**ELECTRONIC APPLICATION OF KENTUCKY)
UTILITIES COMPANY FOR A CERTIFICATE OF)
PUBLIC CONVENIENCE AND NECESSITY FOR) CASE NO. 2022-00066
THE CONSTRUCTION OF TRANSMISSION)
FACILITIES IN HARDIN COUNTY, KENTUCKY)**

**RESPONSE OF
KENTUCKY UTILITIES COMPANY
TO
FRANK D. BROWN AND MARTHA V. BROWN'S
INITIAL REQUEST FOR INFORMATION
DATED APRIL 14, 2022**

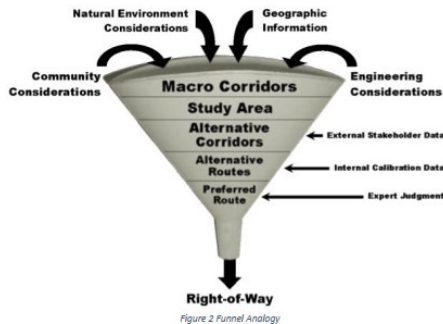
Q-10. Please explain whether KU considered any alternate routes for either proposed 345kV line other than those contained in the Siting Study. If yes, please detail any such routes and why they were not selected or contained in the Siting Study. If no, please explain why not.

A-10. Yes. In preparing its Siting Study, Team Spatial evaluated the entire study area for macro corridors as fully described in the EPRI-GTC Methodology and applied using the Kentucky Siting Model. Team Spatial’s routing methodology identifies the corridors and the tap points for the 345 kV lines in the study. This was done by using the EPRI-GTC Methodology described on page 7 of the Team Spatial report. This methodology breaks the study area into squares and assigns these squares (approximately 10’x10’ for this study area) a score based on land use (page 8). The land use score comes from the Kentucky Siting Model (page 7). Team Spatial was then able to develop macro corridors between the Glendale South Substation and the Hardin Co – Brown North 345 kV line that are lowest in score (most favorable). Once the optimal corridor is identified, the tap point was then selected. This is the basis of how the 345 kV corridors and routes were developed in the Team Spatial Siting Study.
